# ADDENDUM NO. 2

**APRIL 30, 2024**

**20210345 - BL475 - RECREATIONAL SPORTS - DIVING POOL ROOF REPLACEMENT  
INDIANA UNIVERSITY**

**AR100**

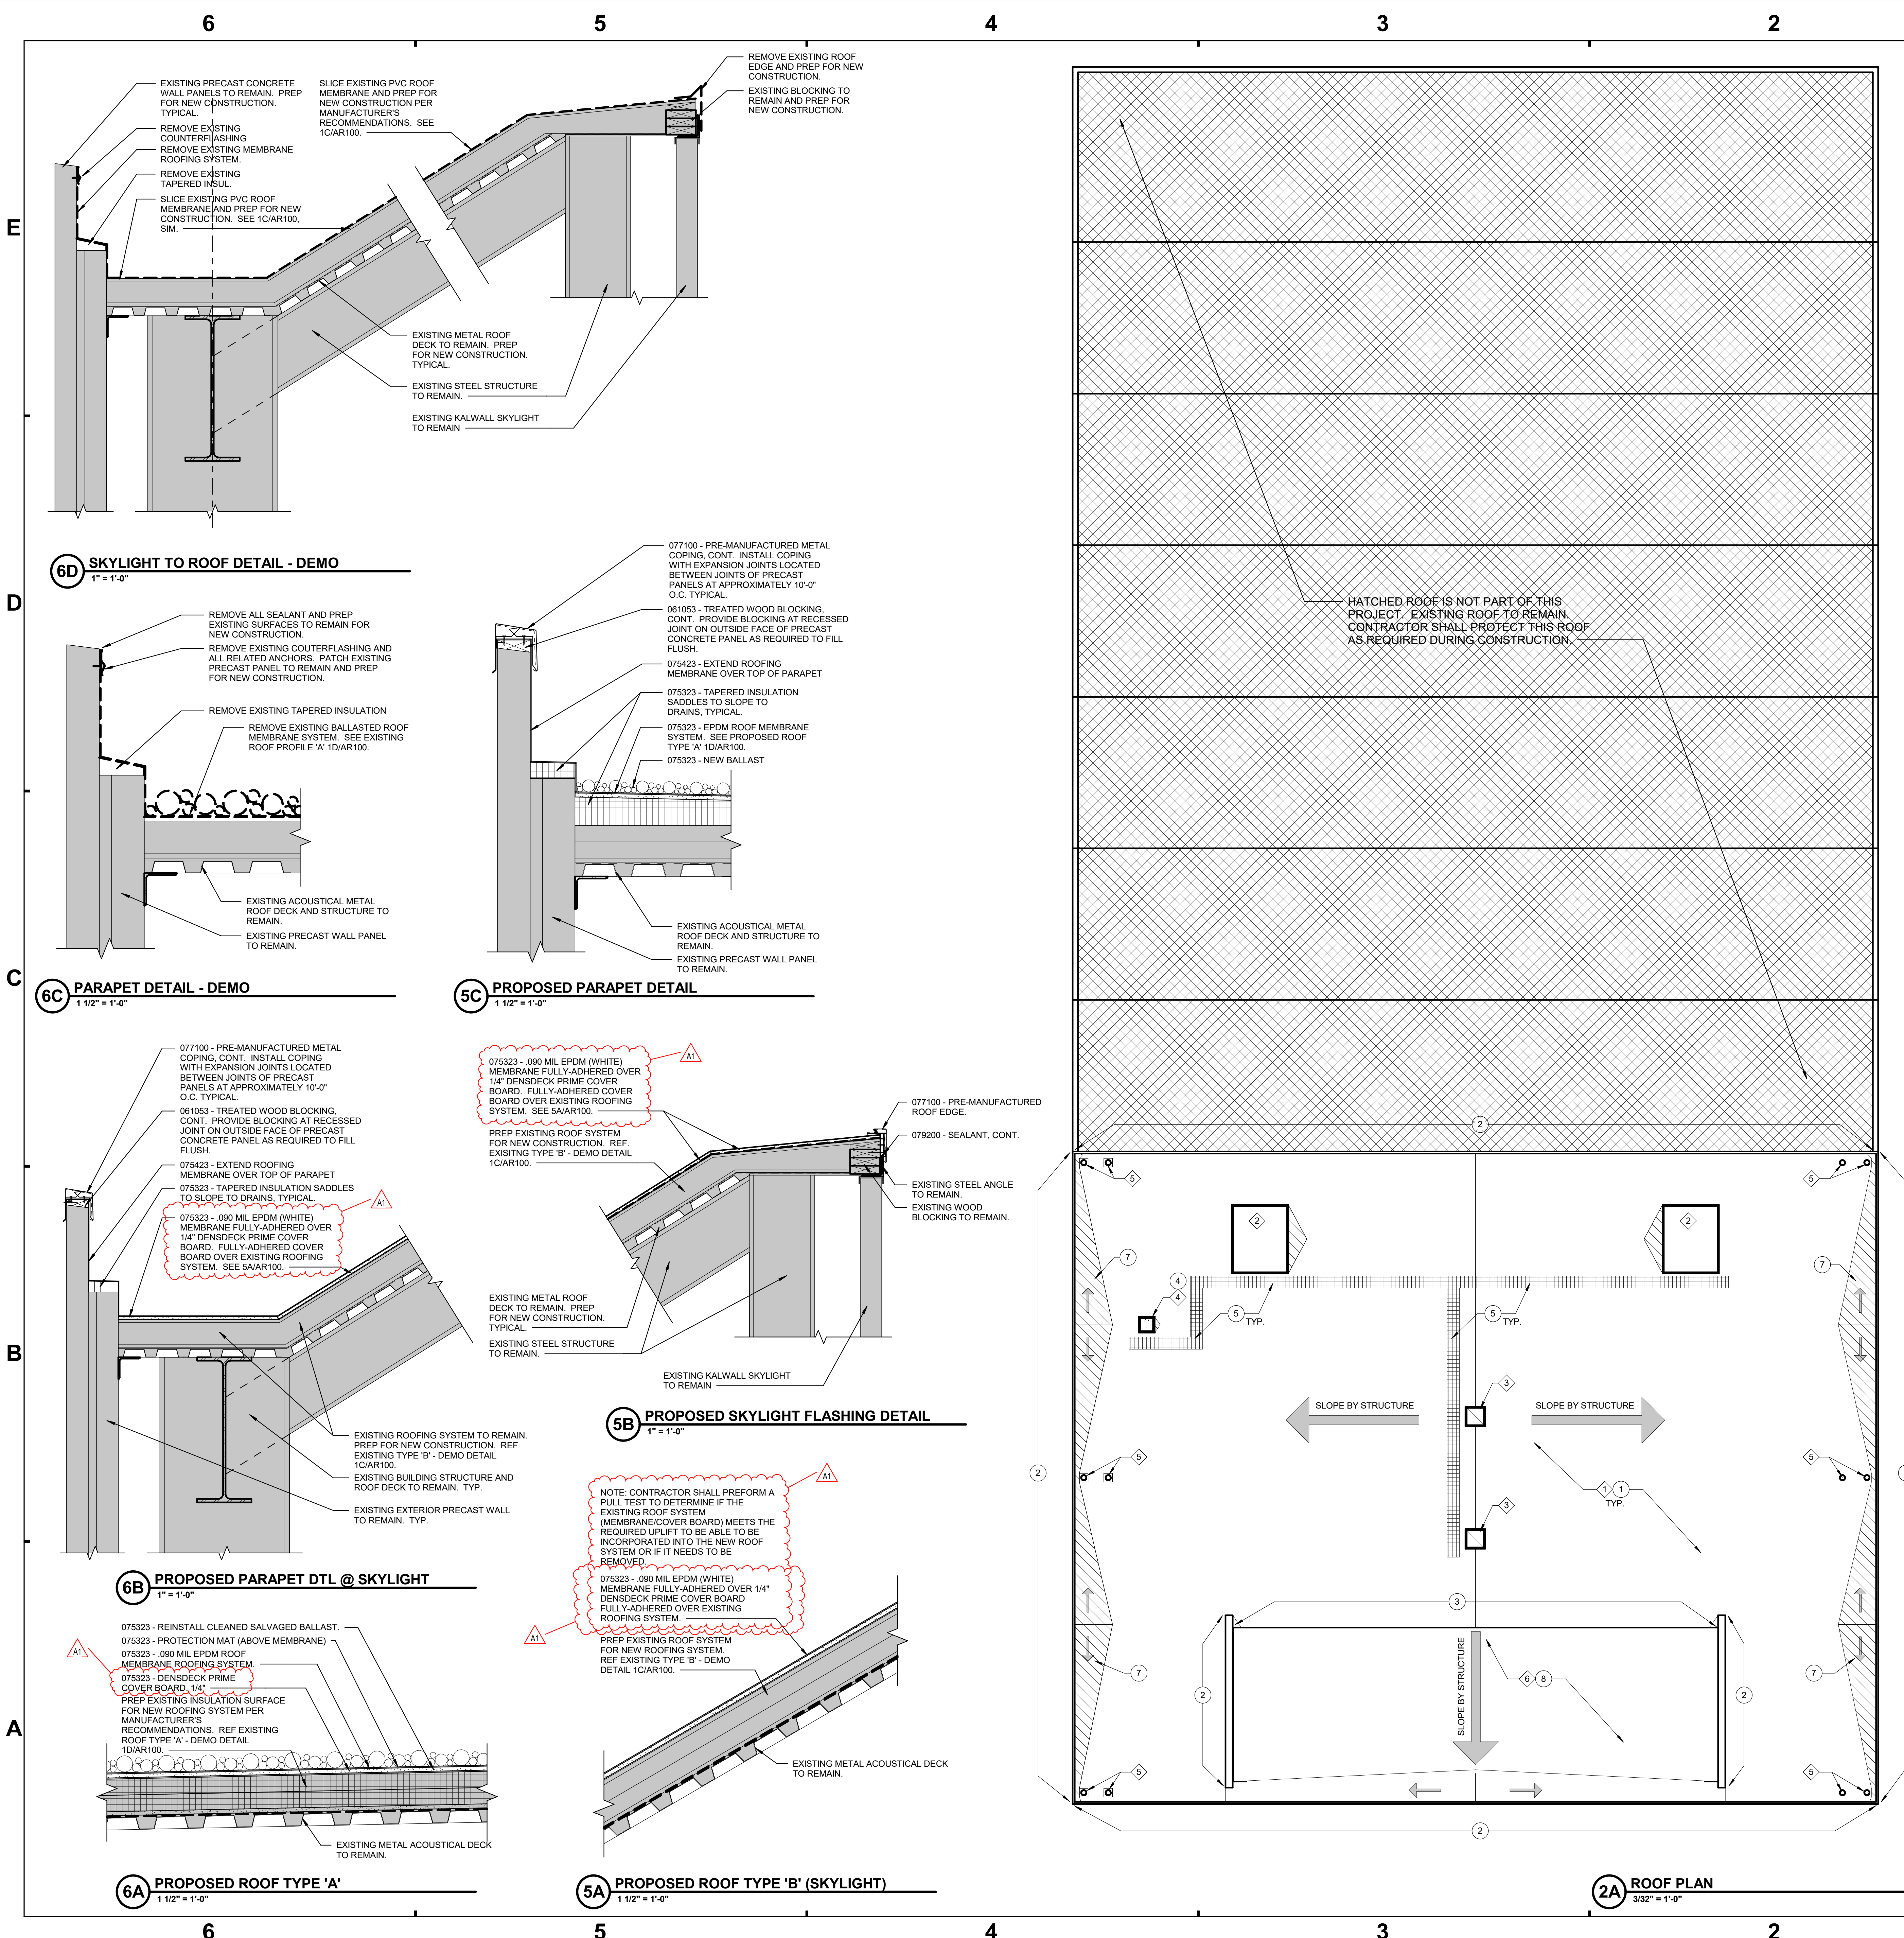
DRAWING NO.	INDICATE ACTION: ADD (A), DELETE (D), DELETE & REPLACE (R),
A-SERIES DRAWINGS	
AR100	DELETE AND REPLACE
